Technical Service Bulletin

SUBJECT:
Ignition System
Cross Fire/Secondary
Ignition Wire Induction

NO: 18-48-98
GROUP: Vehicle Performance
DATE: Dec. 30, 1998

1994 - 1999 (AN) Dakota
1994 - 1999 (BR/BE) Ram Truck
1998 - 1999 (DN) Durango
1995 - 1998 (ZG) Grand Cherokee (International Market)
1994 - 1998 (ZJ) Grand Cherokee

FIGURE 2

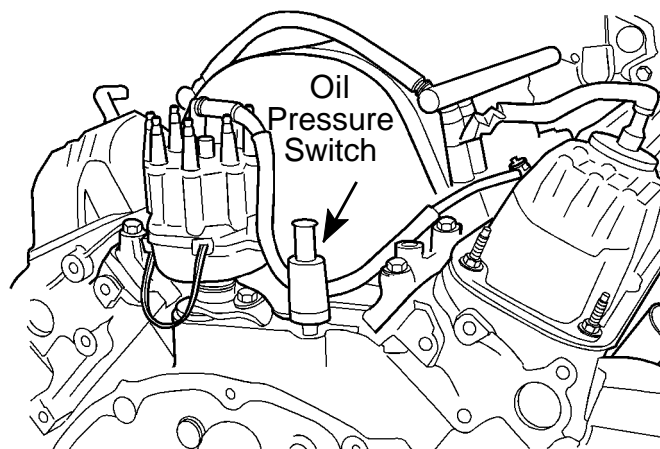
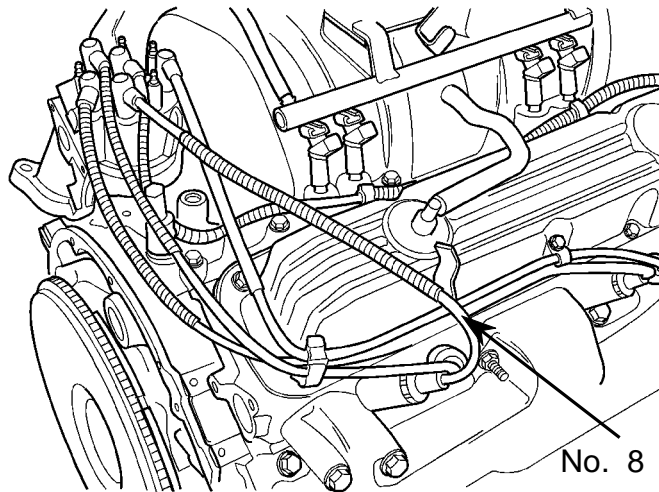
- H. Route the distributor end of the coil wire down and behind the intake manifold, in front of the oil pressure switch (Figure 2).

NOTE: THE COIL WIRE MUST BE A MINIMUM OF ONE (1) INCH AWAY FROM ANY OTHER IGNITION WIRES. THIS MAY REQUIRE THAT THE COIL WIRE BE ROUTED UNDER VACUUM AND/OR WIRE HARNESSES IN THE RIGHT REAR CORNER OF THE INTAKE MANIFOLD.

FIGURE 4

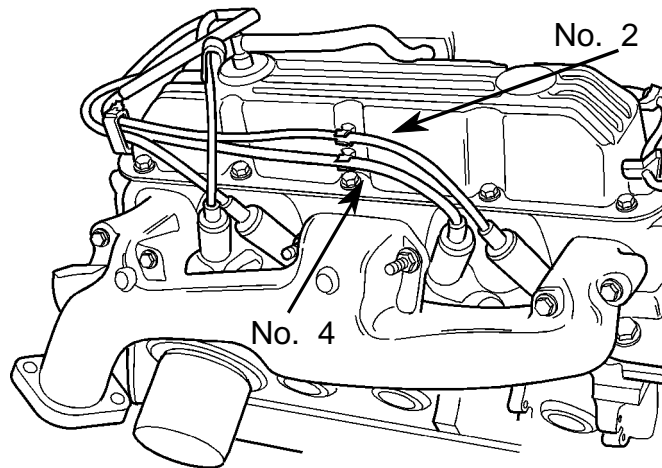
- A. Remove the No. 8 cylinder plug wire from the distributor cap tower terminal.
- B. Remove the No. 8 cylinder plug wire from the five-wire clip located at the lower rear of the valve cover.
- C. Route the No. 8 cylinder plug wire over the rear quarter of the right valve cover (Figure 3).

- D. Position the original piece convolute from the No. 8 cylinder plug wire to prevent chafing at the right valve cover and with other engine components.
- E. Secure the No. 8 cylinder plug wire and its convolute in place with the hose to wire clip p/n 06503441. The small end of the clip is positioned over the convolute. The large end of the clip is fastened to a heater hose (A/C line on ZJ models).

NOTE: MAKE SURE THE NO. 8 CYLINDER PLUG WIRE IS SECURE AND AWAY FROM THE COIL WIRE AND THE NO. 4 CYLINDER PLUG WIRE. MAKE CERTAIN IT WILL NOT FALL DOWN AND CONTACT THE CYLINDER HEAD AND/OR EXHAUST COMPONENTS.

FIGURE 5

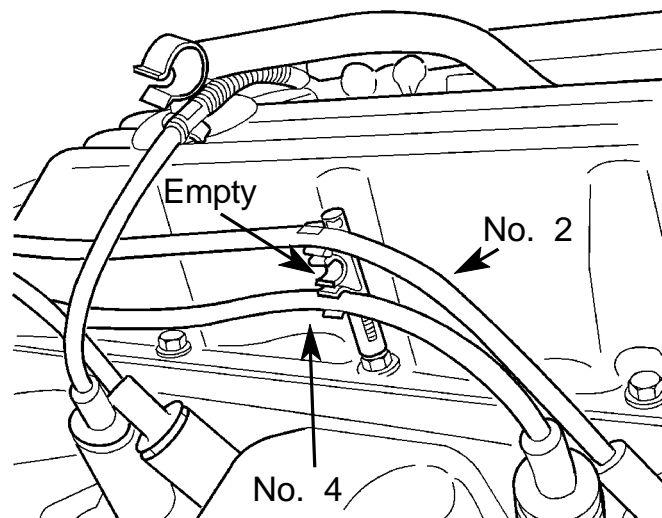
- A. Remove the No. 4 cylinder plug wire from the distributor cap terminal.
- B. At the three-wire clip (located at the center of the lower side of the right valve cover), keep the two wires from crossing and chafing each other. Position the No. 2 cylinder plug wire in the top wire slot and the No. 4 cylinder plug wire in the bottom wire slot. Leave the middle wire slot empty (Figure 5).

FIGURE 7

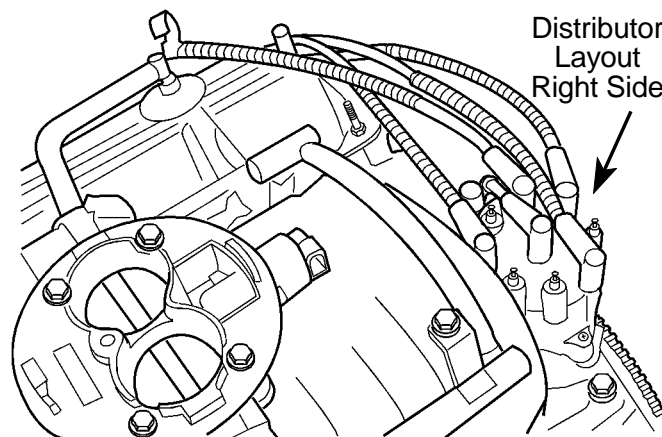
- D. Route the No. 4 cylinder plug wire behind the transmission dipstick tube and heater hoses. On ZJ models this may not be possible due to the location of the bulkhead.

NOTE: MAKE SURE THAT THE NO. 4 CYLINDER PLUG WIRE IS, AT LEAST ONE

INCH, AWAY FROM THE NO. 8 CYLINDER PLUG WIRE.

- E. Install the No. 4 cylinder plug wire to its distributor cap terminal (Figure 7).
4. No. 7 Cylinder Plug Wire Routing (Figure 8 and 9)
- A. Verify that the No. 7 cylinder plug wire crosses over the distributor cap and leaves the distributor cap between the No. 3 and the No. 6 tower terminals (Figure 8). This is the original wire routing for 1998 and prior model years.
 - B. For 1999 M.Y. vehicles the No. 7 cylinder plug wire was shortened. Reroute the No. 7 cylinder plug wire so that it crosses the distributor cap and leaves the distributor cap between the No. 6 and the No. 5 tower terminals (Figure 9).

FIGURE 11

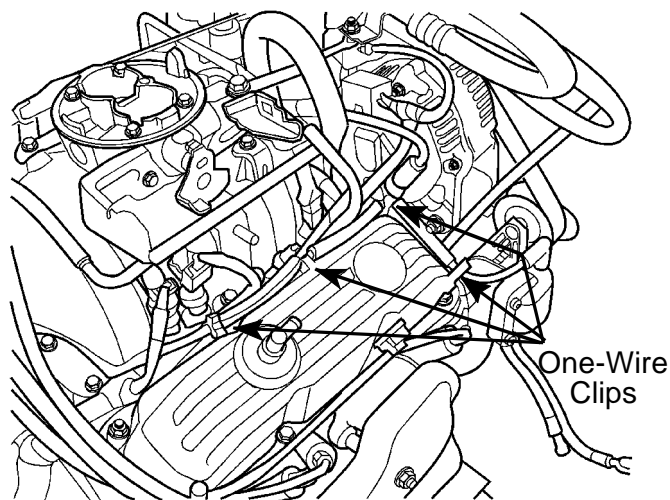
- C. Install three (3) one-wire clips p/n 56028186 along the top and front of the valve cover studs (Figure 11).

FIGURE 12

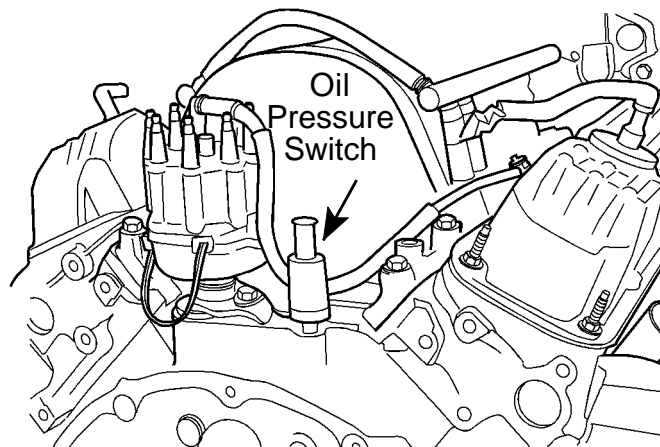
- G. Slit and install the three sections of convolute onto the coil wire between the one-wire clips. Install the 82.5 mm (3.25 in.) section at the front of the right valve cover. Install the two 101.5 mm (4 in.) sections along the top side of the right valve cover. This procedure may be easier to perform while the coil wire is loose from the valve cover (before the clips are attached to the valve cover studs).
- H. Route the distributor end of the coil wire down and behind the intake manifold, in front of the oil pressure switch (Figure 12).

NOTE: THE COIL WIRE MUST BE A MINIMUM OF ONE (1) INCH AWAY FROM ANY OTHER IGNITION WIRES. THIS MAY REQUIRE THAT THE COIL WIRE BE ROUTED UNDER VACUUM AND/OR WIRE HARNESSSES IN THE RIGHT REAR CORNER OF THE INTAKE MANIFOLD.
